EXTINGUISH THE TORCH MEETING SESSION ONE

Project: Turnpike Mainline Shoulder Evacuation NB (MP 210-249)

LESSONS LEARNED

SUMMARY REPORT

1) Mainline and Shoulder typical sections should be constructed in one operation

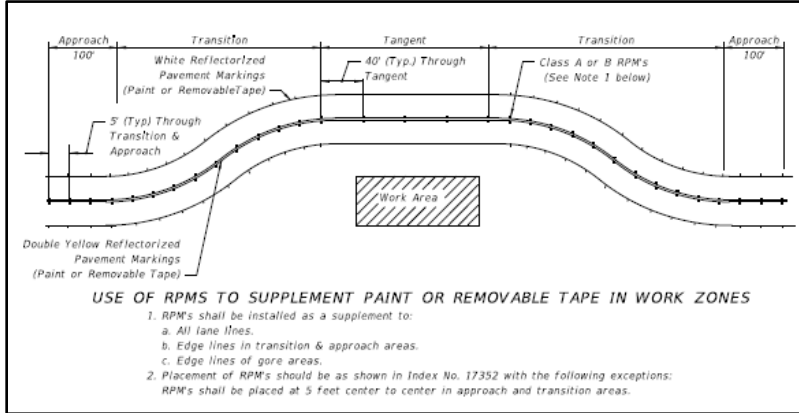
Typical section shows different optional bases and structural course for the 2 to 3.5 foot widening and the 4 foot inside shoulder. It is very difficult to construct and compact the 2 to 3.5 foot widening with the small equipment (plate tamper) required to work in this narrow strip.

During construction, to expedite the construction and to achieve better quality, the widening and shoulders were constructed with same typical section (same as widening) at MP 241.94, MP 243.56 and MP 244.87. This required 104.8 tons of additional TLD Poly, 334.2 tons of additional TLB and 202.0 tons of additional TLD (over-runs).

The EOR should consider same typical section for widening & shoulder, when total width of construction is less than 8'.

2) Transition approach distance for milling and resurfacing limits

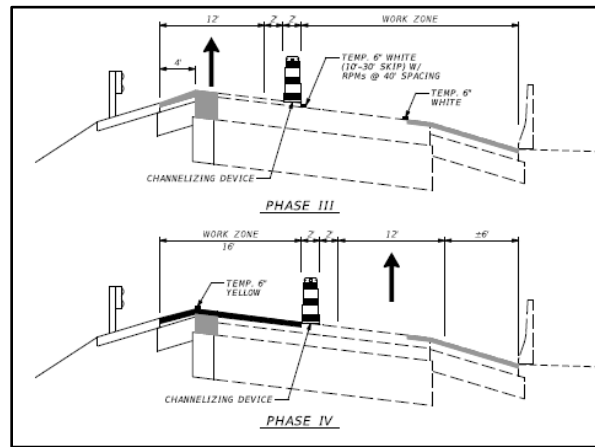
MOT plans did not account for transition approach distance of 100' to be included with milling and resurfacing.

Extended the milling limits 100' at MP 229.37, MP 241.94, MP 243.56 and MP 244.87 to remove the strips outside MOT plan limits. This required additional 756 SY of 3/4" mill and 31.2 tons of additional FC-5 (over-runs).

Milling and resurfacing limits should include transition approach distance as per Standard Plans.

3) Milling and resurfacing of existing travel lanes

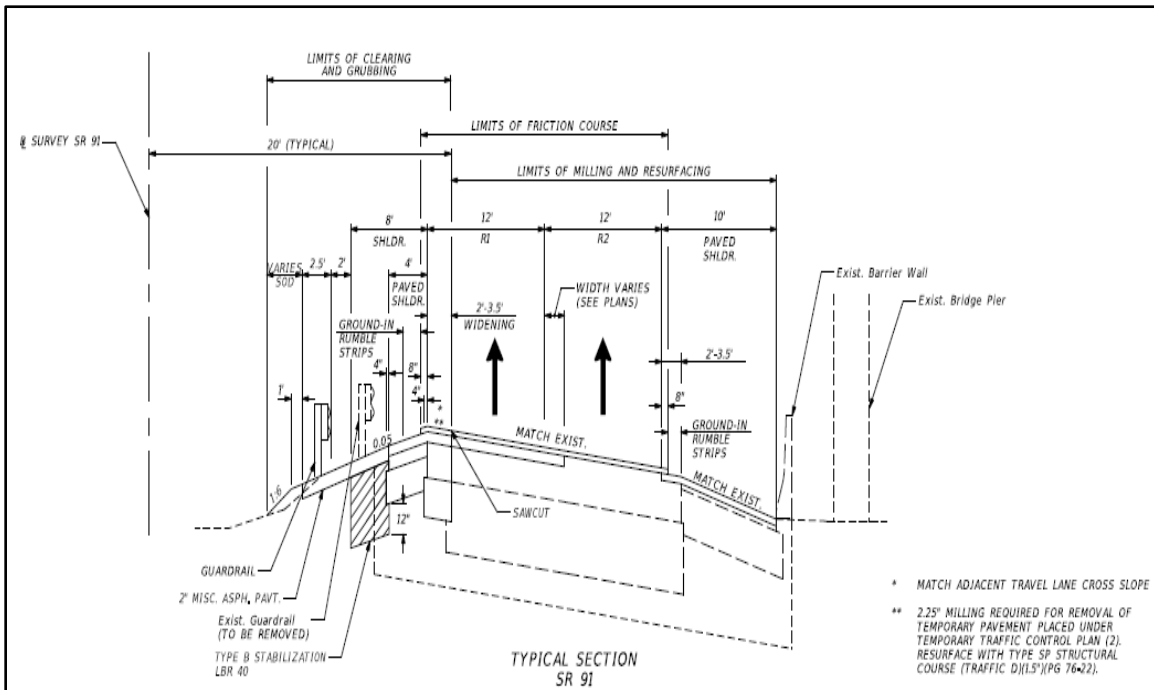
The traffic control plan called for milling the existing friction course on the outside travel lane in phase III. Then mill and resurface the inside travel lane (structure course) in Phase IV. Phase V called for placement of friction course on both travel lanes. Milling the friction course in the outside lane would have left a milled surface until Phase V. Even though Special Provision Section 327 allowed traffic on the milled surface for up to 3 calendar days, FTE and the CEI were concerned that weather would likely impact the work on the inside lane (which had to be milled and resurfaced with structure course and friction course), resulting in traffic being kept on the milled surface for more than 3 days.

During construction, the contractor did not mill the friction course in the outside lane (Phase III) until after the inside travel lanes were resurfaced with structure and friction. This allowed the traffic to shift to final configuration as the FC-5 was placed and traffic was never placed onto a milled surface.

The EOR should avoid leaving milled surface and should call out placement of friction course same night of milling.
